Sheet: /		
File: AudMix.kicad_sch		
Title:		
Size: A4	Date:	Rev:
KiCad E.D.A. 8.0.3		Id: 1/6

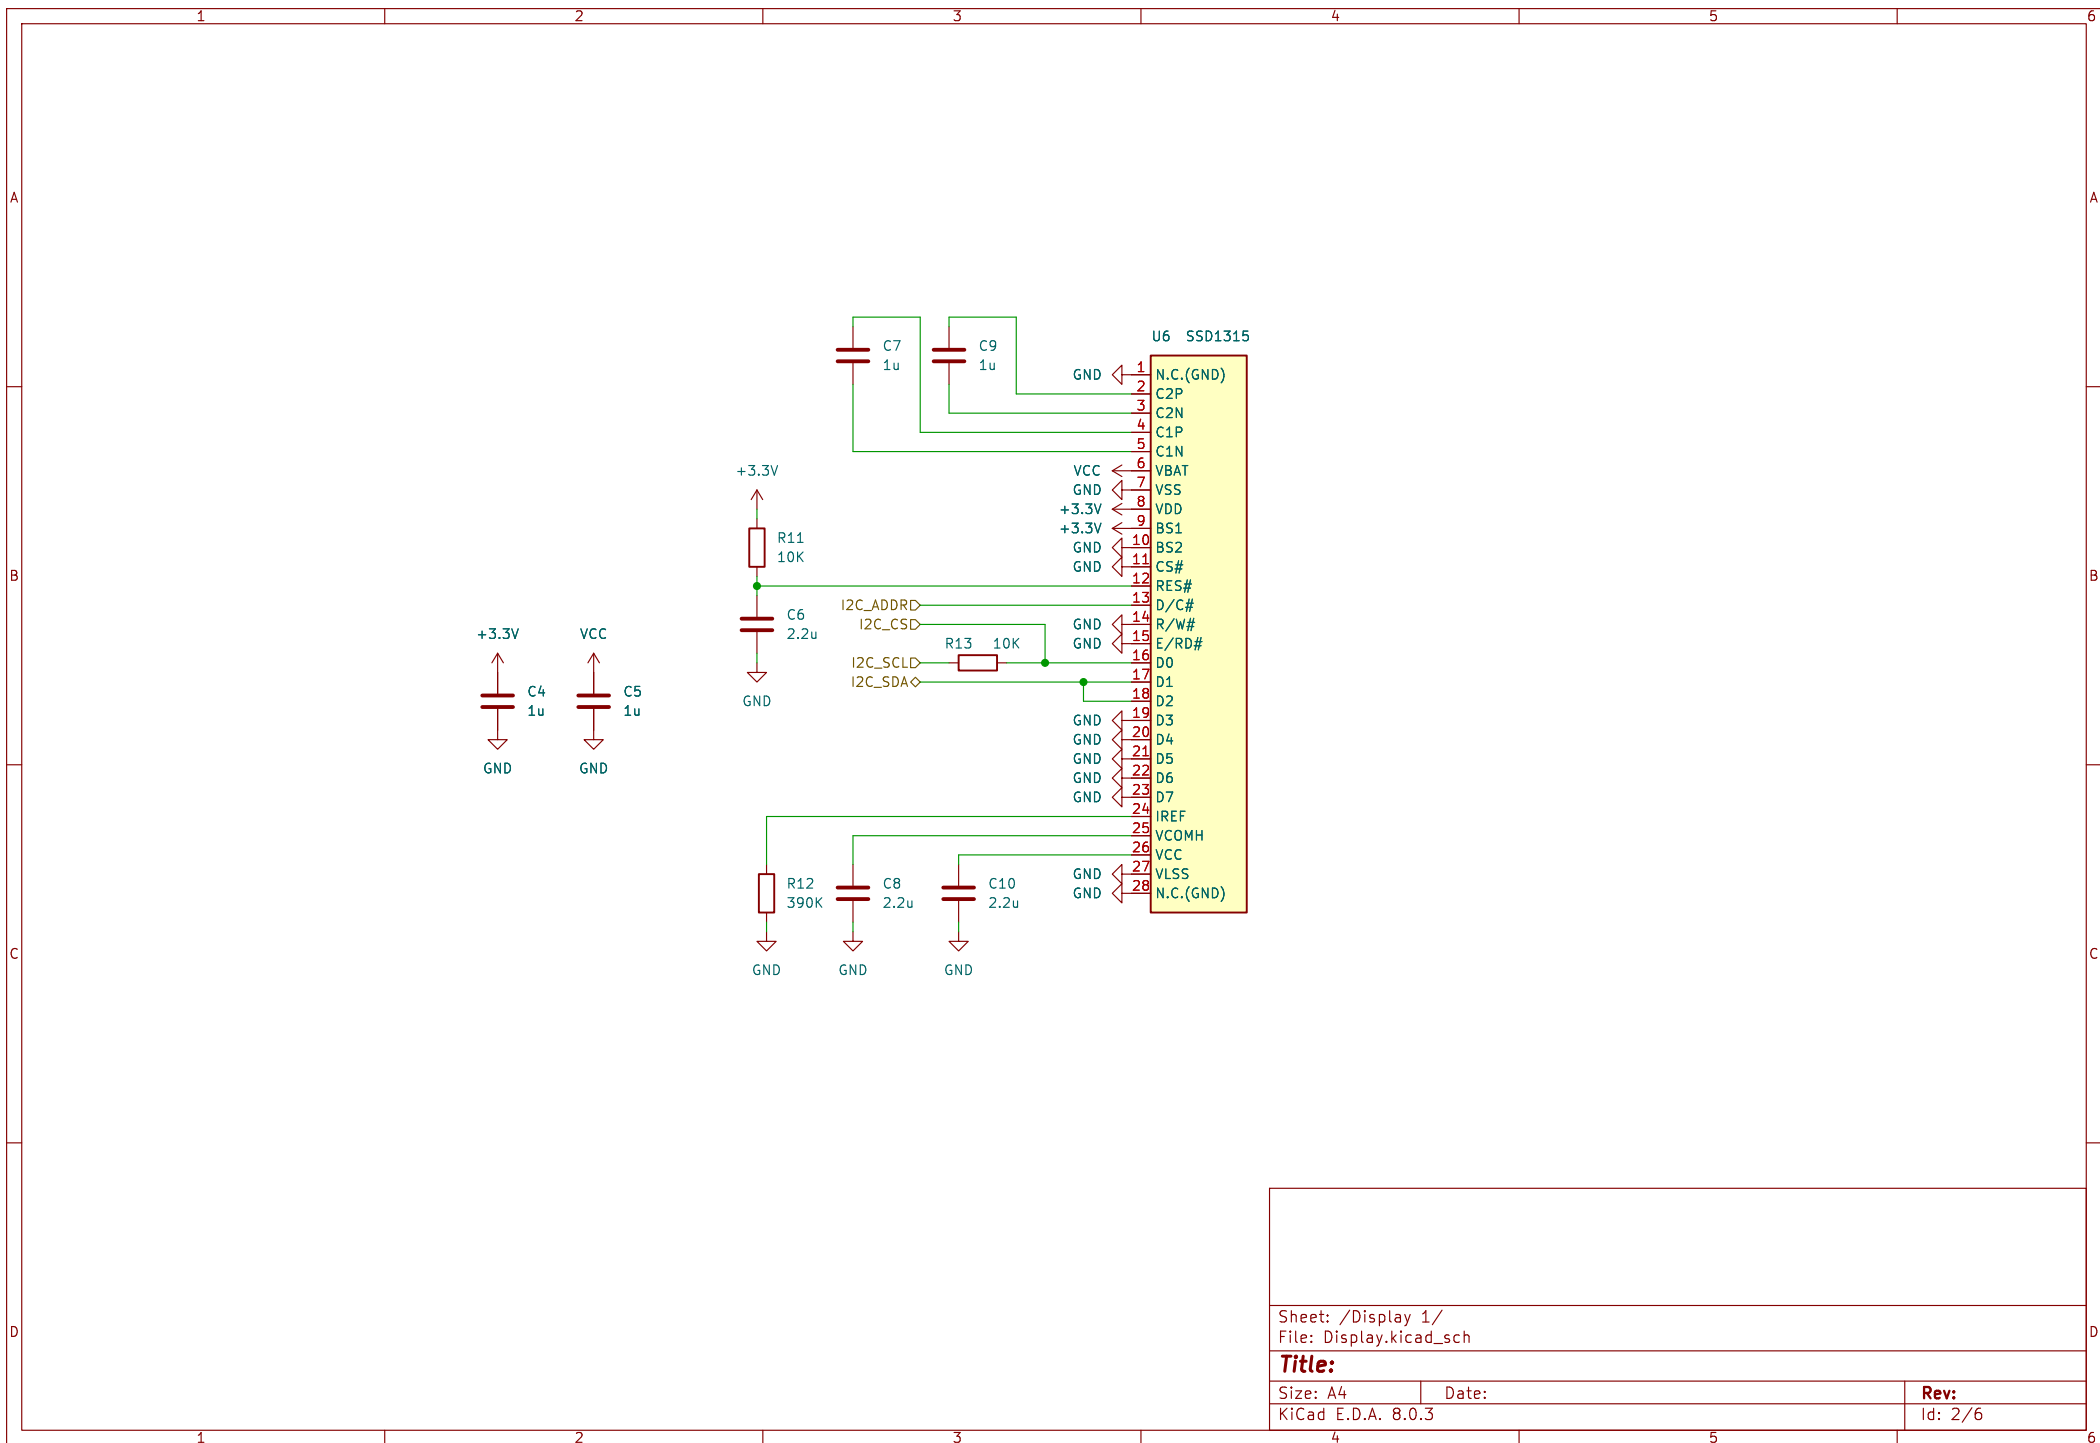
- Error list:
- 1) Voltage drop on AMS1117 to high, min battery voltage 3.9V
 - 2) I2C_CSx should be I2C_SCLx
 - 3) I2C_SCL should be pulled up to 3.3V
 - 4) LDO on ESP32C3 module should be removed
 - 5) Battery "+" and "-" reversed on PCB silkscreen
 - 6) R6 should be 100k, R1 should be 390k
 - 7) Charge current should be lower (0.5A)
